SUBJECT: REQUEST FOR ADDITIONAL INFORMATION - DAVIS-BESSE NUCLEAR  
POWER STATION (TAC NO. MB8953)

By letter dated May 14, 2003, you submitted a request for amendment to the Davis-Besse Nuclear Power Station Operating License, NPF-3, which would modify the Technical Specifications by allowing entry into Mode 3 operation during the current outage only with neither high pressure injection (HPI) pump capable of taking suction from the low pressure injection system trains when aligned for containment sump recirculation. The HPI system will otherwise be operable.

REQUEST FOR ADDITIONAL INFORMATION  
DAVIS-BESSE NUCLEAR POWER STATION  
DOCKET NO. 50-346

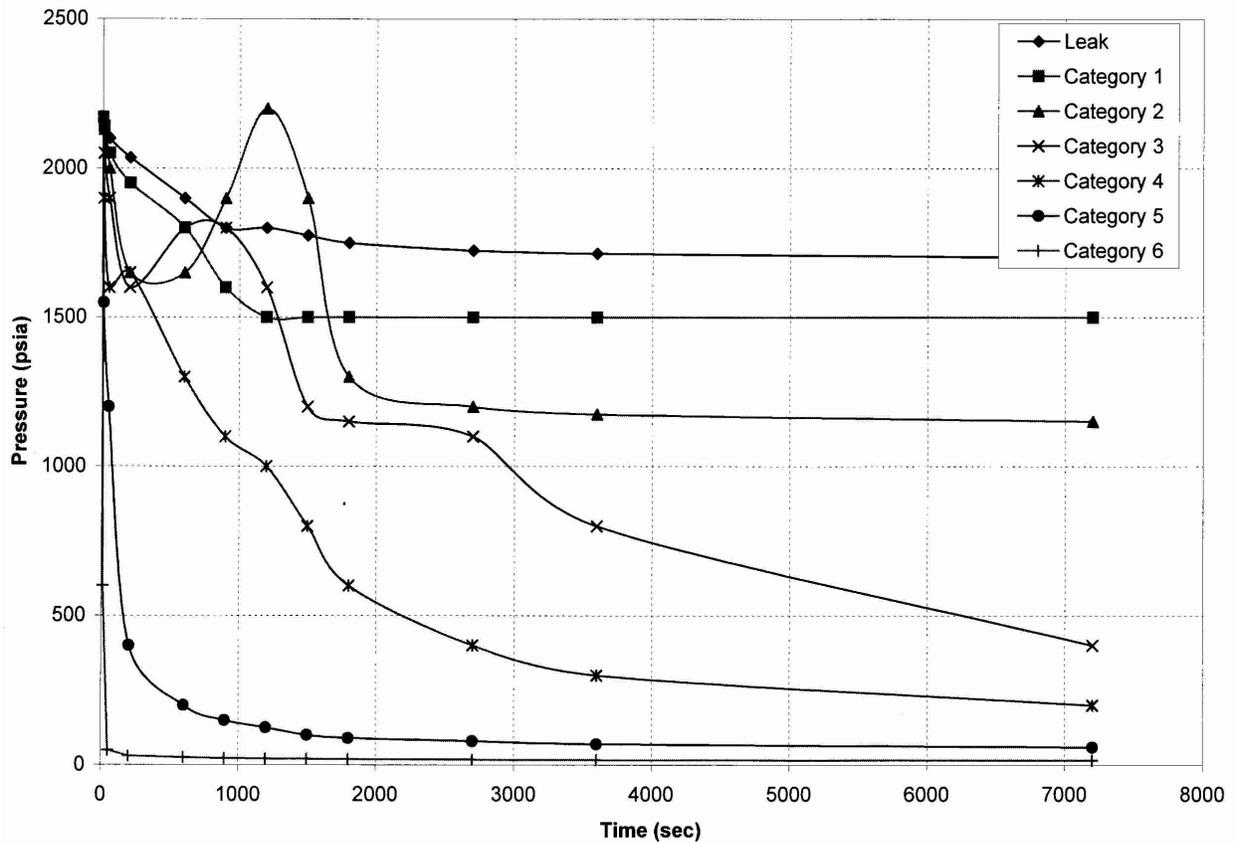
- 38. The ANP Page 44 discussion indicates a 3.5 percent head reduction was assumed for HPI flow rate. Is this a conservative assumption when the concern involves HPI flow causing RCS pressure to remain high?**

Mode 3 Pressure-Time Histories

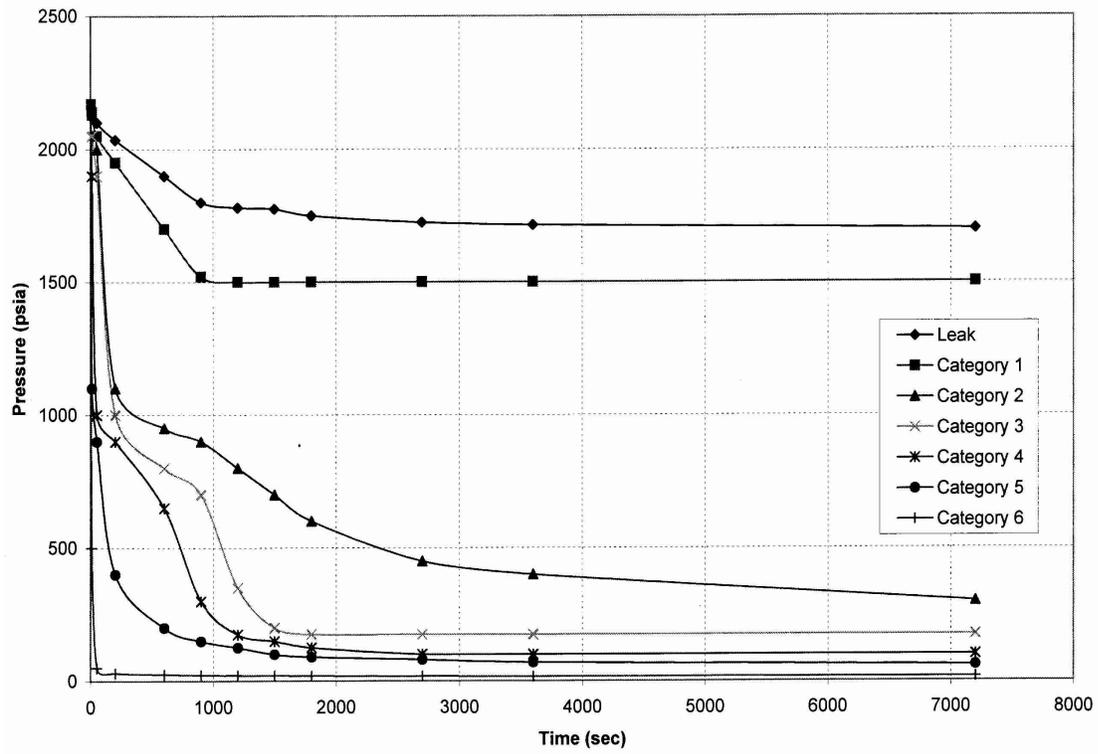
- 43. Provide docketed copy of the RCS pressure/time histories (full power as well as Mode 3) as supplied by FANP.**

The following preliminary copies of LOCA response were provided at Lynchburg, VA:
